Recall Campaign Bulletin

Campaign No. 2023070012, May 2024

Revision F: 08/12/2024

Replace Fuel Pump Delivery Module – Wave 6

Figure 2

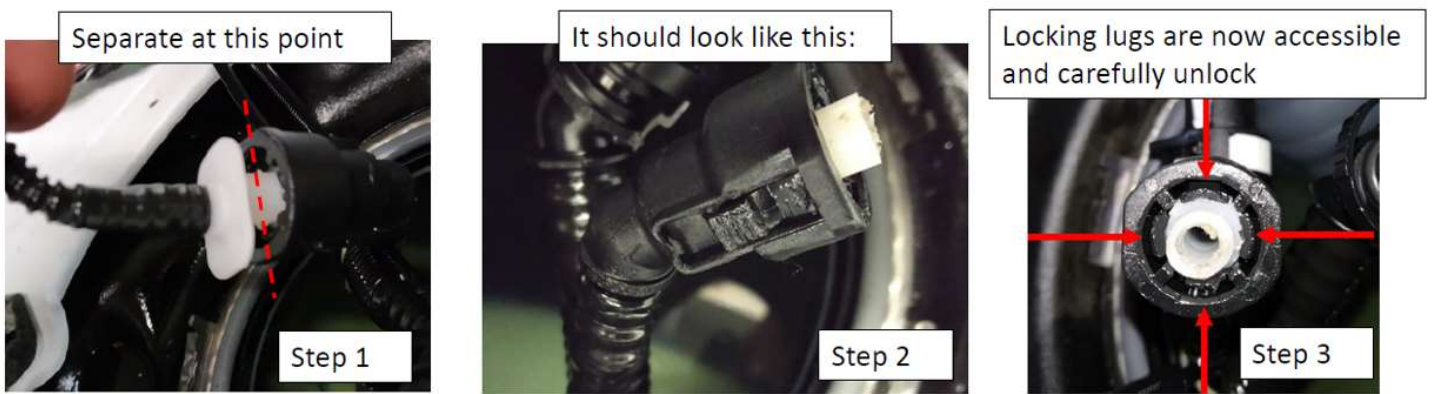
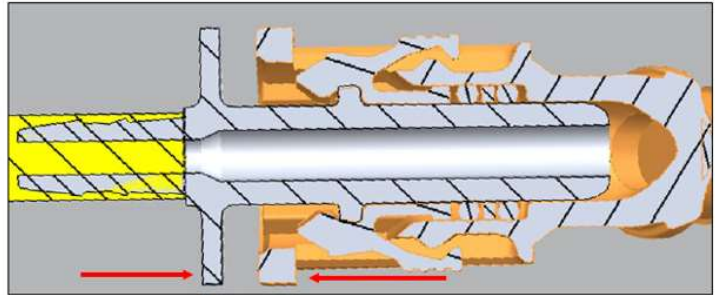
i Only model 206, 232: Note on disassembly of suction jet pump drive line quick connector. The procedure step 1-3 should only be performed when the quick disconnect is not working (**Figure 2**).

MRA2 Quick Connector suction jet pump drive line

Squeeze the QC connection by at least 1mm, then unlock the latching lugs. If this is not possible. Step 1 -3

Figure 3 (release corresponding connector and disconnect the contacts)

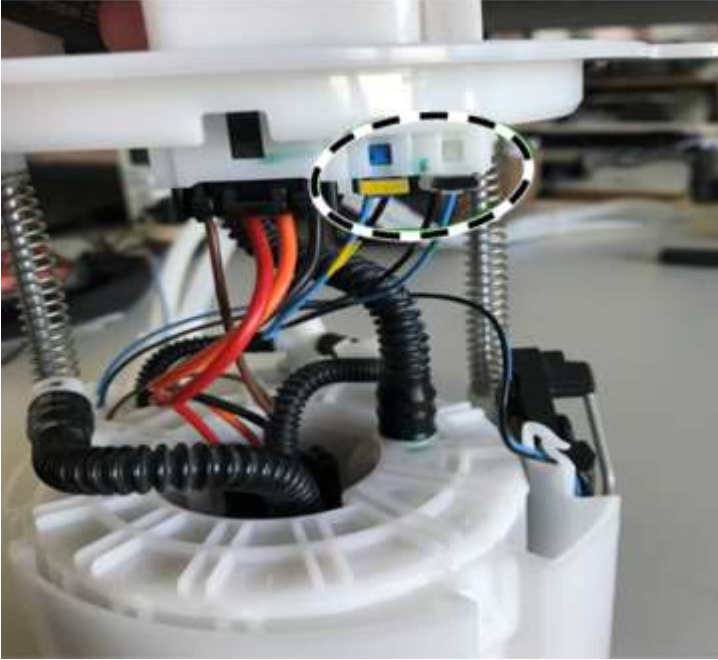
i Delivery modules that are delivered **without float-and-lever sensor** must be modified. (Figures 3-5)

Figure 4 (remove lines from routing clip)

Figure 5 (using a screwdriver, carefully push float-and-lever sensor housing away from module housing and at the same time push float-and-lever sensor housing upwards.)
